SAN FRANCISCO PLANNING DEPARTMENT

Discretionary Review Full Analysis

Date: October 26, 2017
Case No.: 2016-009062DRP-02
Project Address: 505 Grand View Avenue
Permit Applications: 2016.11.23.3441 & 2016.06.30.1337
Zoning: RM-1 [Residential-Mixed, Low Density]
40-X Height and Bulk District
Block/Lot: 2828/044
Project Sponsor: Kerman Morris Architects
137 Noe Street
San Francisco, CA 94114
Staff Contact: Nancy Tran – (415) 575-9174
Nancy.H.Tran@sfgov.org
Recommendation: **Do not take DR and approve as revised**

Alteration of windows:

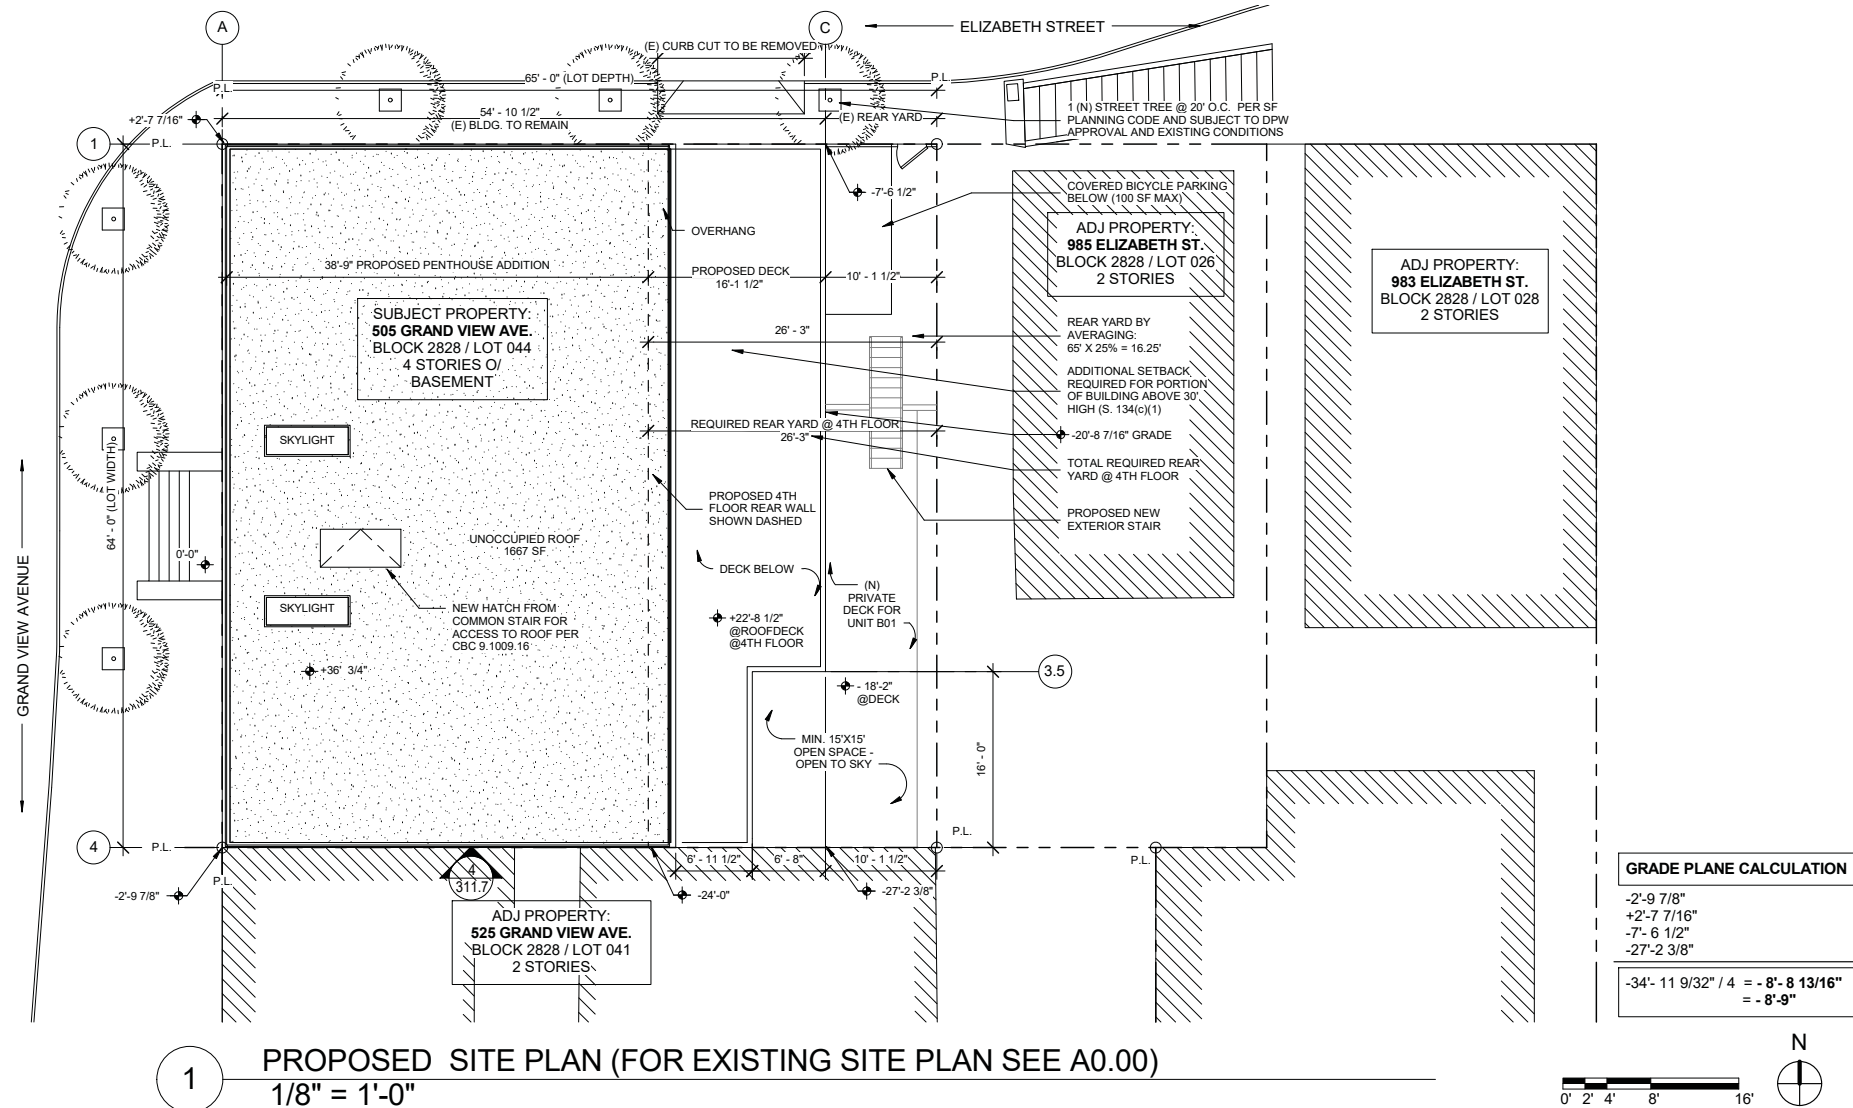
The alteration of the exterior is necessary to the addition of the ADUs, the proposed plan changes on the 3rd/4th floors, and the thermal performance of the structure. With the Planning Department required removal of the decks to accommodate the 15'x15' open space serving 2 ADUs, the units above will need to alter their respective exterior wall areas. Also, the wall changes associated with the upper floors will not be feasible with the existing window locations. Finally, the window upgrades are part of California's Title-24, Part 6 Energy Efficiency Standards, and are part of a larger effort to make the building more energy efficient.

The project is required by the Planning Department to make exterior changes to add the ADU's (removal of decks and reconfiguration of existing windows), as well as accommodate new upper floor unit layouts, and increase overall building energy efficiency. These changes are integral to the design and function of the project. The owner will not be able to make the wholesale changes requested by the DR applicant to "Disapprove the window changes" to the entire building.
